CITY OF ALBUQUERQUE

October 2, 2025

RE: **Lot 1 Block 9 Unit 5 SAD 227
6200 Keyenta Pl. NW
Volcano Cliffs Subdivision
Grading and Drainage Plan
Engineers Stamp Date 9/19/2025 (E10D131, HYDR-2025-00340)**

ENGINEERING SHEET:
CIVIL GRADING PLAN
 OF
 PROJECT NAME:
6200 KEYENTA PL NW
 FOR
 CLIENT:
PALOMARES

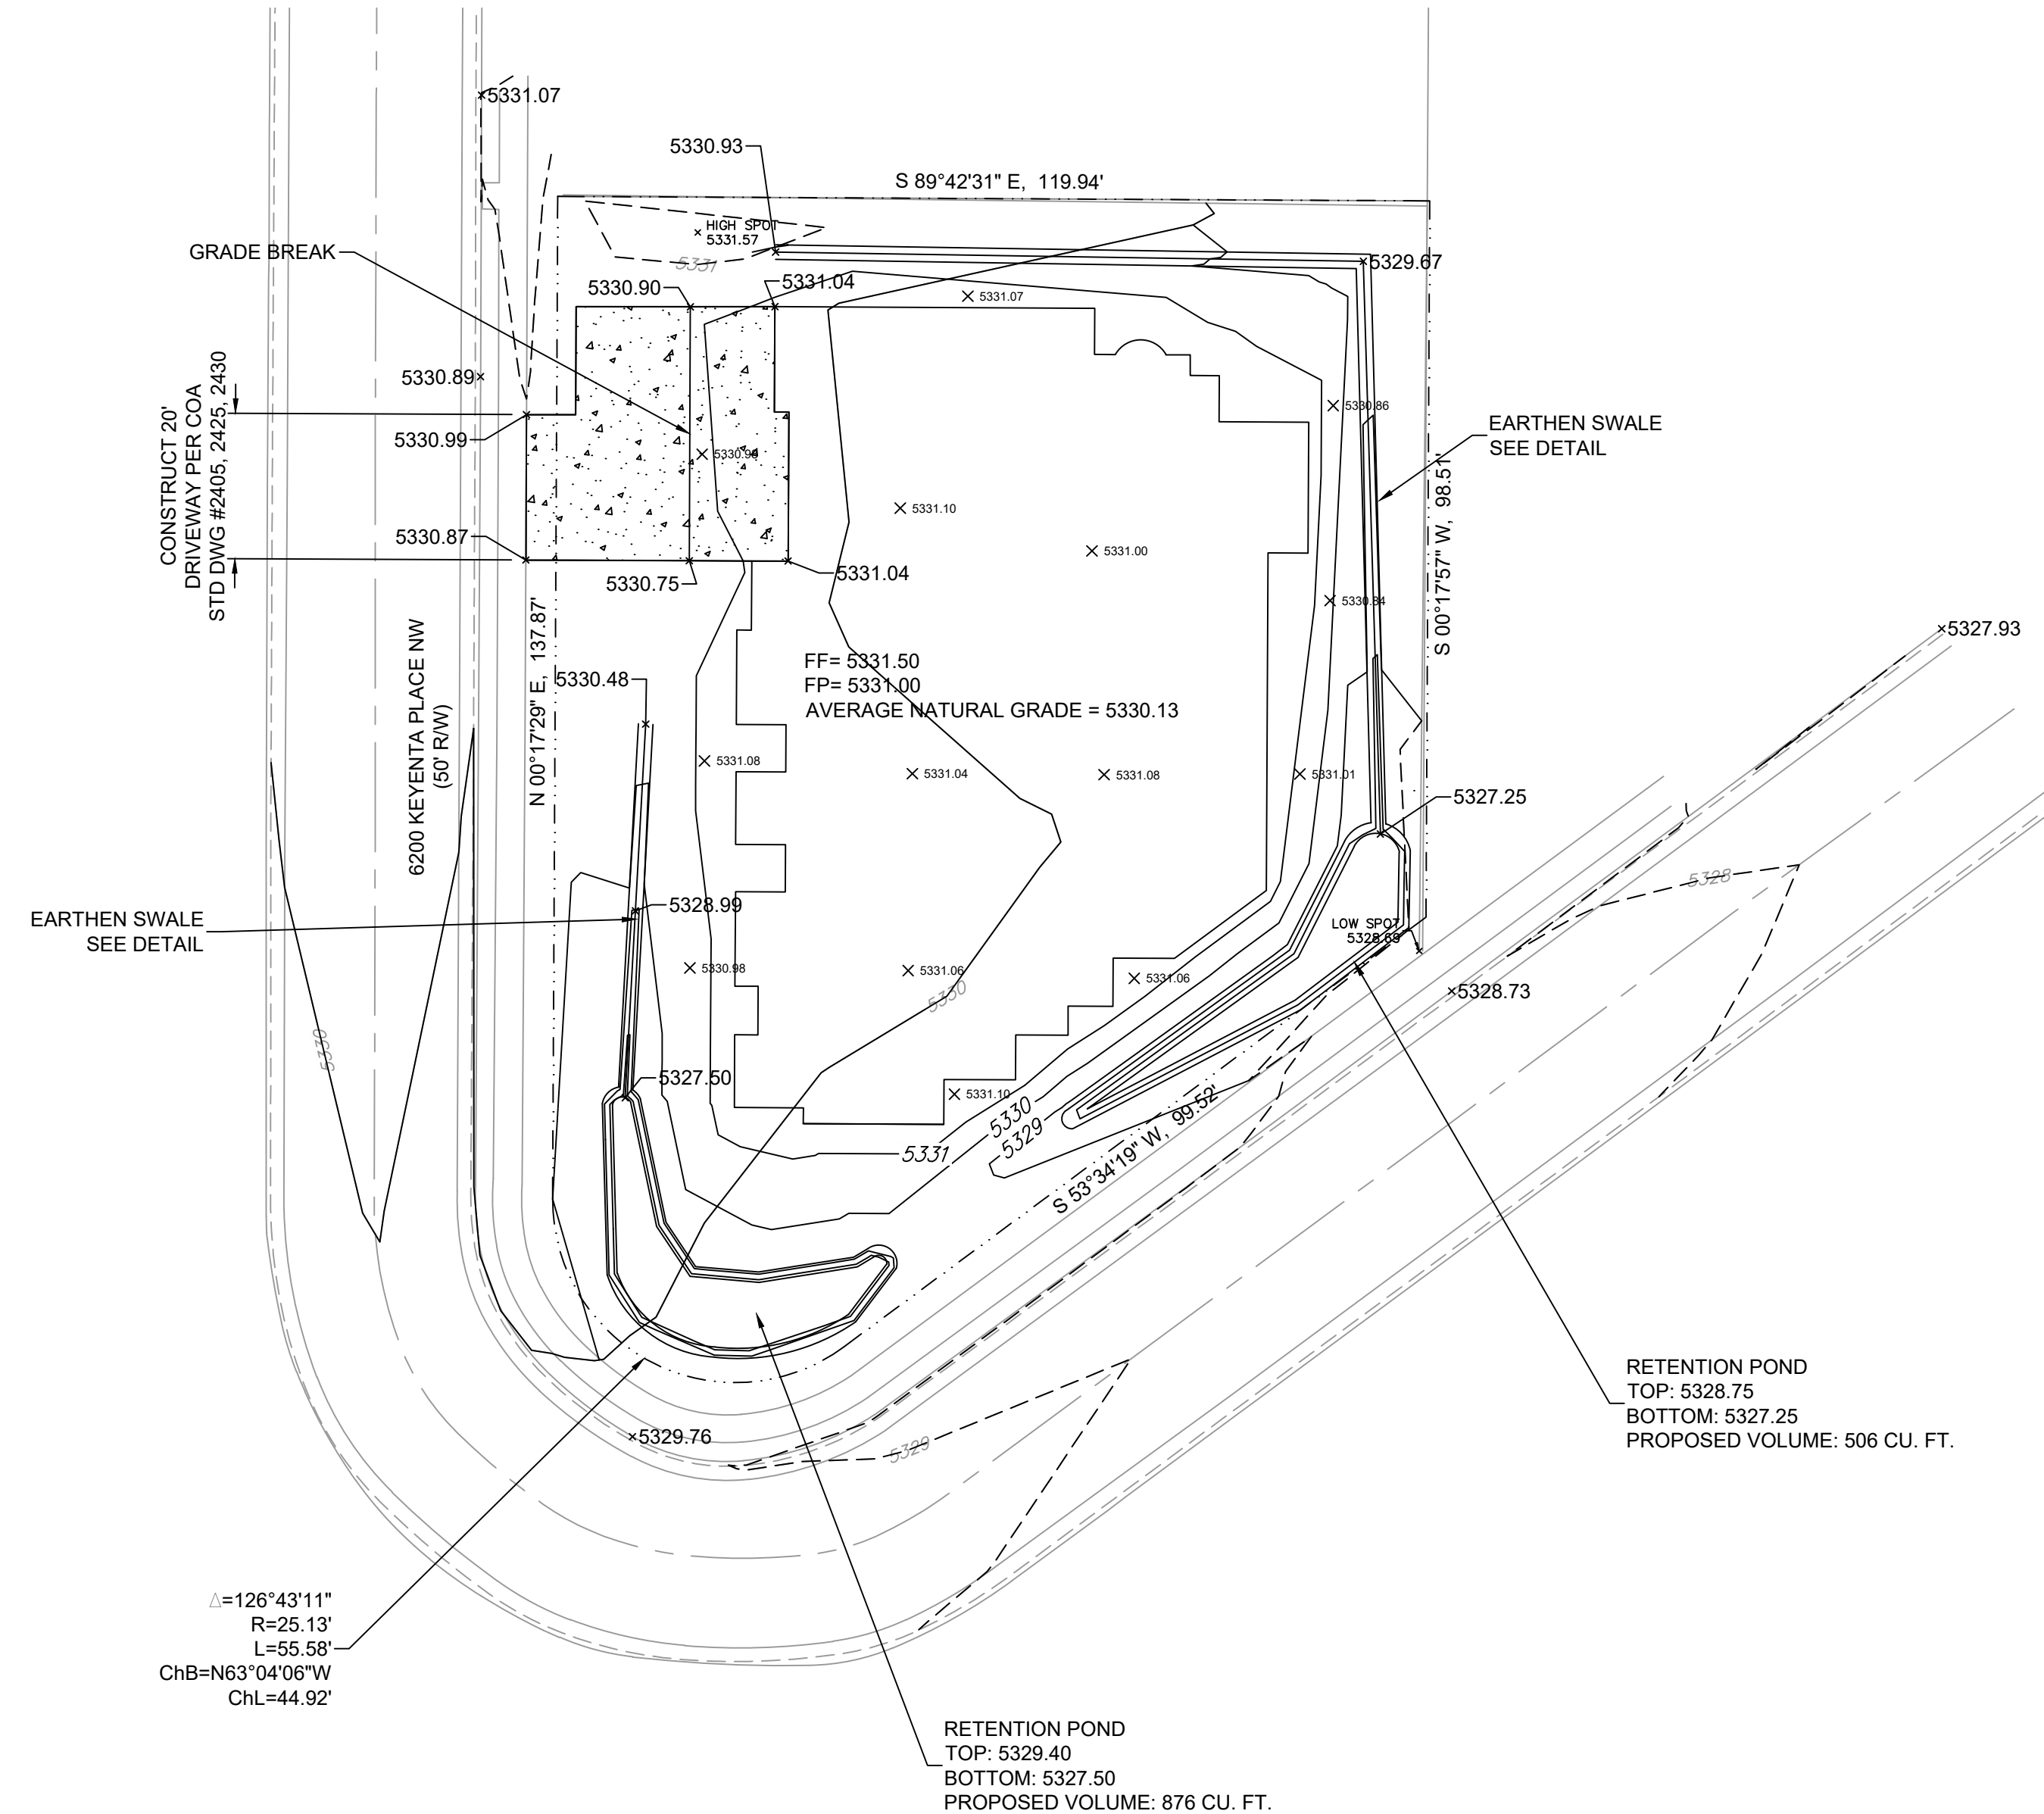
Prior to Building permit approval a Pad Certification will be required, provided by the Engineer or a registered Land Surveyor, with appropriate fees to be paid.

Advise the owner contractor not to use dirt as a ramp to climb the curb, use lumber or crusher fines for this purpose. Place this note on the plan.

Reiterate to the Owner/Contractor that a separate permit for a garden/retaining wall must be obtained with the approved G&D plan and Pad Certification. Also, if a swimming pool is to be placed after this approval a new grading and drainage plan will need to be resubmitted showing the changes for the land treatments.

Prior to Certificate of Occupancy release, Engineer Certification per the DPM checklist is required.
